Our Ref: J31314

RE: ESKOM EIA CONCERNS FOR THE PROPOSED NUCLEAR POWER STATION AND ASSOCIATED INFRASTRUCTURE (DEA Ref. No: 12/12/20/944)

P:\J27035 Nuclear Power Station (TA)\TasseilReview of Transport Specialist Study\Jan 2012\Images\Coast\Thyourn\Figure 9.5_2012_Eastern Bypass Alternatives.dwg | RADNMS | 05/07/2012 10:43:04 AM

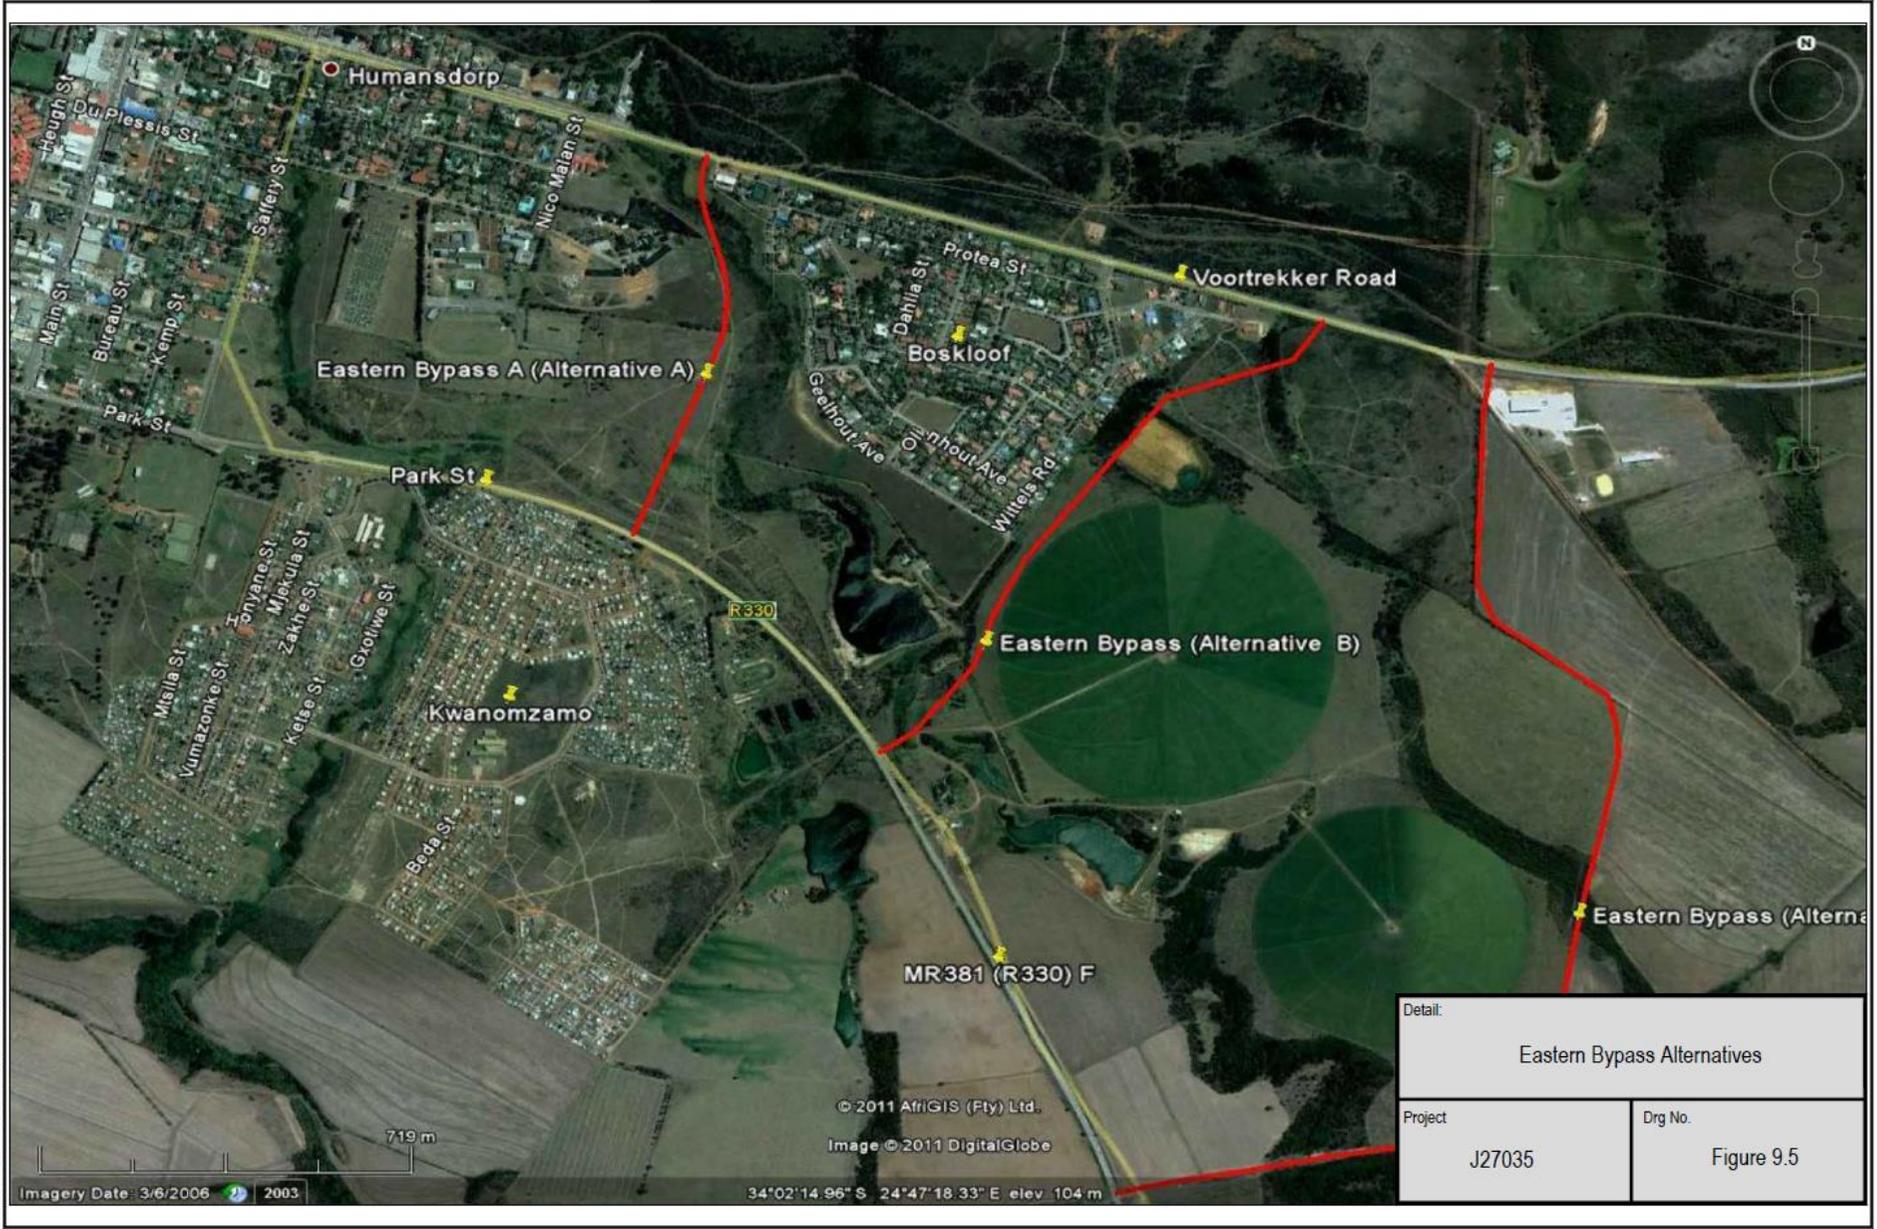
The access road you are planning on using Saffery Road is totally unsuitable this is a residential area, firstly have these property owners been informed that you are planning on sending +- 950 trucks per day through their residential area. This road is already in a terrible state full of potholes and is a very narrow road so how can it be possible for trucks to use this as access. The road does not even have a shoulder or pavement on. There will be a huge pedestrian risk and there are three schools along your planned access route namely St Francis College, Sea Vista Primary and Humansdorp Secondary I fear for the safety of these children. Also the Sandriver Bridge is consistently being flooded and it has washed away twice in the last month leaving us stranded with no evacuation route to leave the village in any event of an accident at the proposed plant.

Your comments are noted. Similar concerns from the public around Humansdorp area up to St. Francis have been raised and acknowledged. As such the Transport Assessment has been revised to consider other alternative routes. The revised report recommends that the main street through Humansdorp and Saffrey Street be bypassed. New transport roads for abnormal load vehicles were therefore considered and three alternate bypasses were investigated, as shown in the figure below. All three alternatives are proposed new roads that run along existing land boundaries between farmland. Furthermore, please note that bypass roads to the east and west of Humansdorp are also now proposed to be constructed to reduce the traffic impact on central Humansdorp.

Alternative A directly links between Voortrekker Road (MR389) and Park Street (MR381) and is 850 m in length. The beginning of Alternative A crosses the Boskloof Valley and the rest of the route will be constructed on Municipal land.

Alternative B is connects between Voortrekker Road (MR389) and Park Street (MR381) along the east of the Boskloof area, and crosses privately owned farmlands and is 1.3 km in length. The topography

of Alternative B is considered acceptable, except for the section of the route where it crosses the Boskloof Stream at a deep vertical alignment. Additional cost will be required for the construction of a bridge to cross the stream at an acceptable grade.

Alternative C is located the furthest east from Humansdorp and is the longest of all three alternatives (2.7 km). This route also crosses privately owned farmlands. Similar to Alternative B, Alternative C crosses two relatively deep valleys, which will require additional cost for the construction of bridge structures to achieve acceptable grade crossings.

Alternative A is therefore considered as the most viable option as it is the shortest and most economical route to construct, and it has a good alignment for the transportation of abnormal loads. Once the route is constructed, it will also alleviate the traffic congestion in Humansdorp.
